CAIRNGORMS NATIONAL PARK AUTHORITY

Title: REPORT ON CALLED-IN PLANNING APPLICATION

DEVELOPMENT PROPOSED: ERECTION OF 30 (AMENDED TO 25) HOUSES AND CONSTRUCTION OF ACCESS ROAD ON LAND SE OF MILLSIDE HOUSE, MILTON, AVIEMORE

REFERENCE: 09/153/CP

Figure. 3- Original Submission Layout

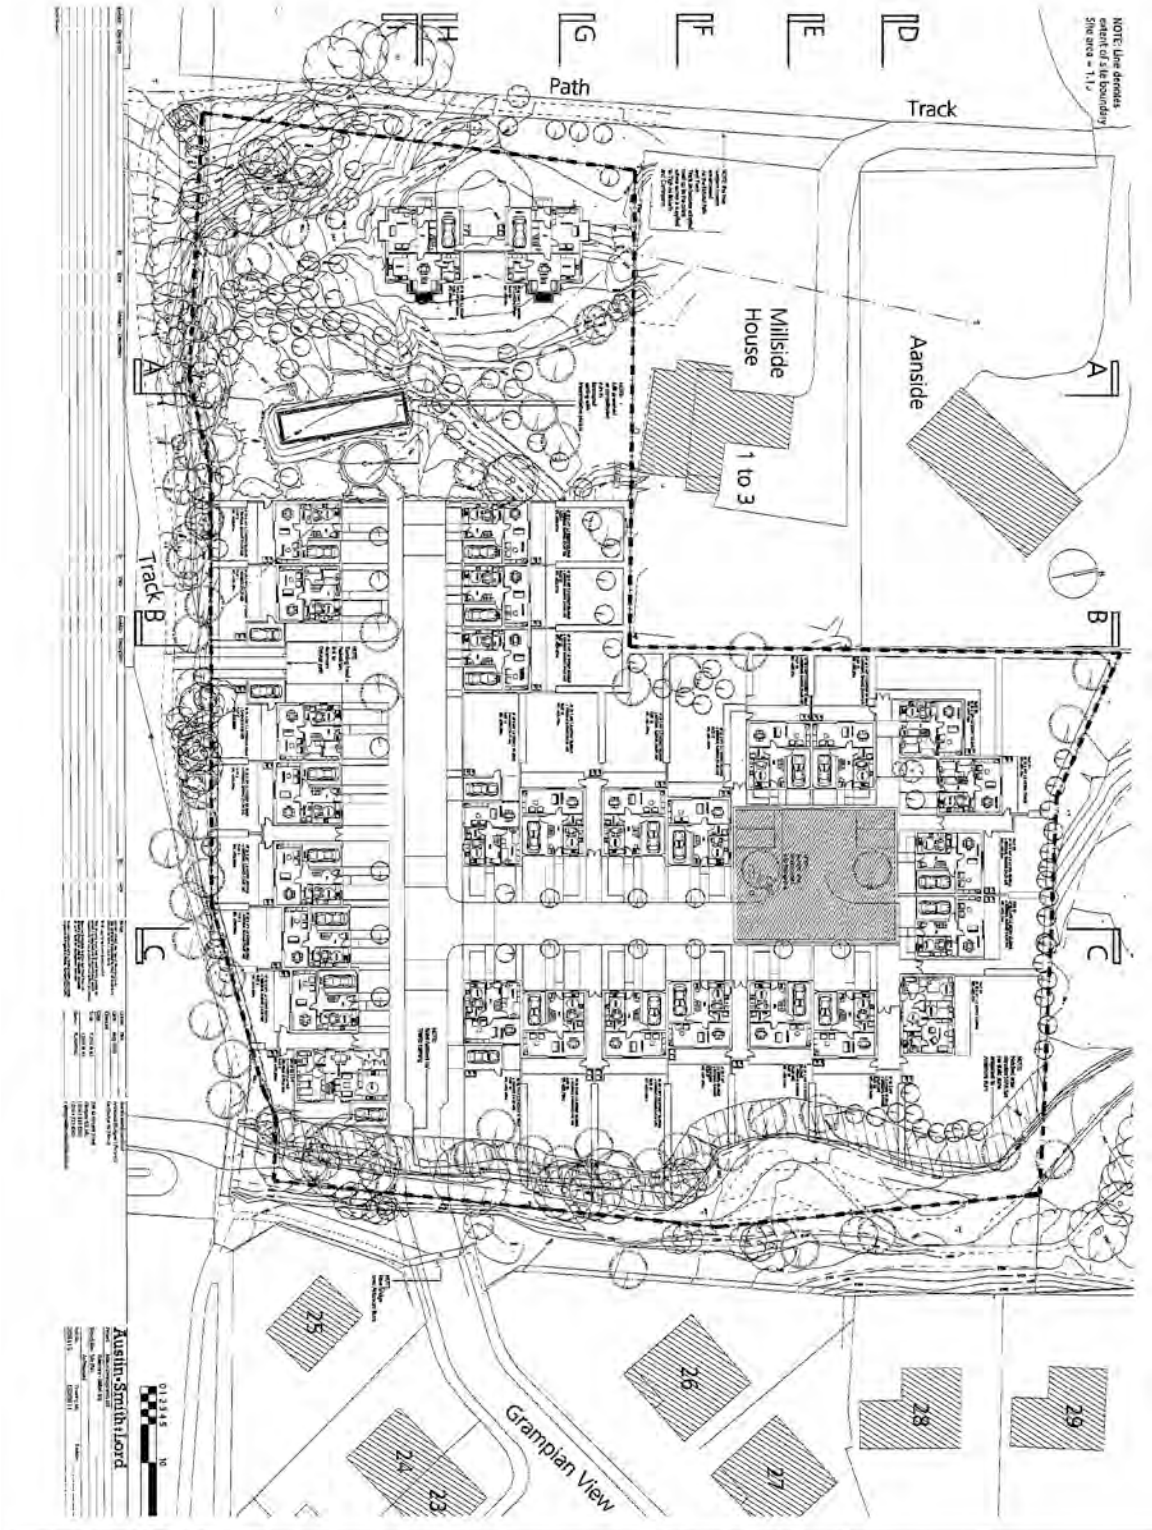
32. **CNPA Natural Heritage: Landscape:** The principle of housing is supported for the site. However there are significant details that require further consideration. The layout is generally introspective and does not allow for good integration with the site context. The relationship with the path to the south is considered to be poor. With regard to the pedestrian entrance onto the path from the southern side of the development the question is asked whether this could be sited at the junction of the spur road. The road entrance is dominated by building and high walling without amelioration. The change from the burn side is very abrupt and a softer approach here would be greatly beneficial. The 'gatehouse' is too close to the burn and breaks the continuity of the garden space/burn side relationship. It should be omitted and a greater emphasis placed upon tree planting in this area. The use of hedging is not a particularly characteristic boundary in Aviemore. There has been a strong emphasis on stone walling. There should be more of an emphasis upon dry stone walling particularly at the road junctions. The roofs on the rear elevations on the southern line of houses appear perfect for solar gain. A full planting plan will be required.

50. A higher density approach than that advocated by the Badenoch and Strathspey Local Plan is accepted by officers. The courtyard approach is considered a positive design solution, in principle and the strong two storey street frontage tapering to single storey at the rear elevations is a creative way of designing a positive and strong street frontage while minimising the visual impact of the proposal from outside of the site. However, the more recent changes amending the scheme down to 25 units has resulted in certain concerns. Because of concerns raised about parking the applicant had been asked to delete plots 11-13 which are immediately to the south of Millside House backing onto the steepest part of the site which also has significant tree cover and a wet area. It was suggested that this area could be used for additional parking for houses on the opposite side of the road. The current plans for the 25 units have deleted one house on the south side of the road which leaves plot 7 (closest to the mill) isolated from the remaining houses and surrounded by parking spaces. This is not an attractive environment for the occupier of the house and this arrangement would detract from the setting of the Mill. This again hints at the difficulty of accommodating the units proposed on the site leading to the conclusion that the proposal still constitutes over-development. This is apparent when the density is seen against the physical constraints of the site as opposed to the flat plan area that the density covers.

2. The siting and layout of plots 7, 11, 12 and 13 of development fail to maintain and enhance the distinctive landscape of this part of the National Park and also fails to complement and enhance the character, pattern and local identity of the built and historic environment. Consequently the proposal is contrary to the Strategic Objectives of the National Park Plan for Landscape and Built Environment which seek to: a) maintain and enhance the distinctive landscapes across the Park; c) seek to ensure that development complements and enhances the landscape character of the Park, and d) seek to ensure that new development is settlements should complement and enhance the character, pattern and local identity of the built and historic environment.
